CUSTOMER SATISFACTION PROGRAM

SUBJECT: Hood Striker Corrosion / Fracture

MODELS: 2015-2016 Chevrolet Colorado
2015-2016 GMC Canyon

This bulletin is being revised to update the corrosion protection information in the Parts Section and Service Procedure. Please discard all copies of Customer Satisfaction Bulletin 15116.

4170778

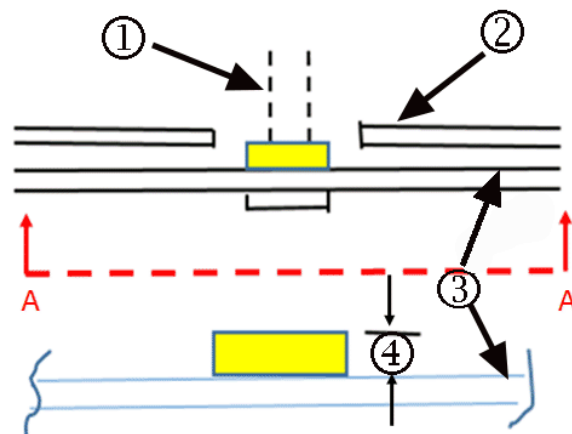
Key to Call-outs Noted Above

- (1) Forward screws
- (2) Stationary hood striker
- (3) Rear, inboard hood clinches

1. Open the hood and verify components noted above.

4175312

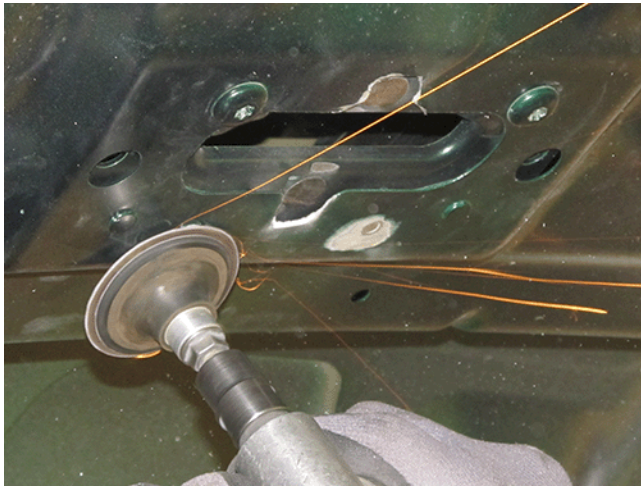
Important: When grinding is complete, use a height gage to ensure the remaining striker nub (shown in yellow above) height is no taller than 1.5 mm (0.060 in) (4) above the base metal reinforcement (3).

4. After removal of the striker (1), use a grinding wheel or belt sander to grind down the remaining striker nubs. The nubs should be shorter than the hood inner surface (2) and stand a maximum height of 1.5 mm (0.060 in) above the base metal reinforcement (3).

4170790

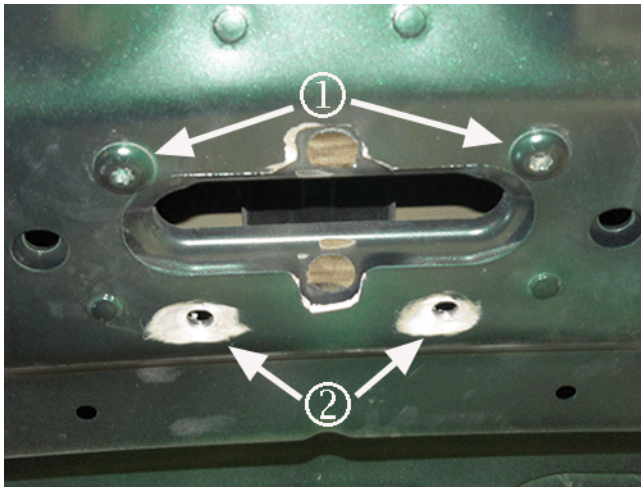
5. As shown in the graphic above, grind flush the two inboard, rear clinches,

4170794

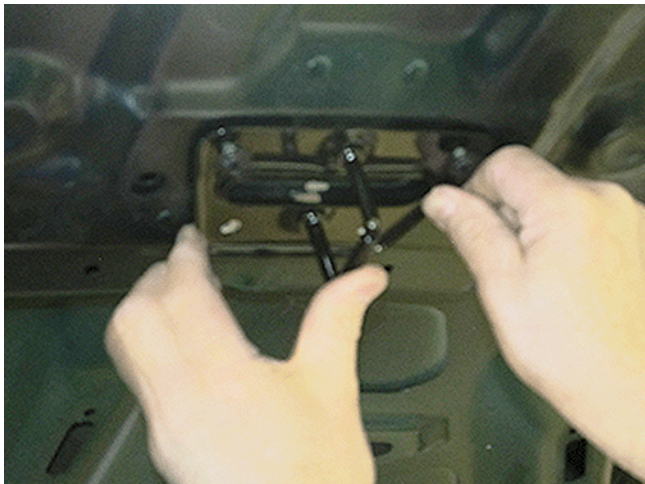
Important: After drilling, flatten or remove any burrs inside the drilled holes.

6. Once these clinches are ground, two small holes will be exposed. Using an 8 mm drill bit, carefully drill out these two rear holes (2), until through the layer of metal.
7. Remove the two forward screws (1), shown above.
8. Prior to applying the corrosion protection, position the new striker plate to the hood to ensure the new drilled holes align with the holes in the plate. In some cases, you may need to open up a drilled hole on one side or the other, to allow for alignment of the new plate.
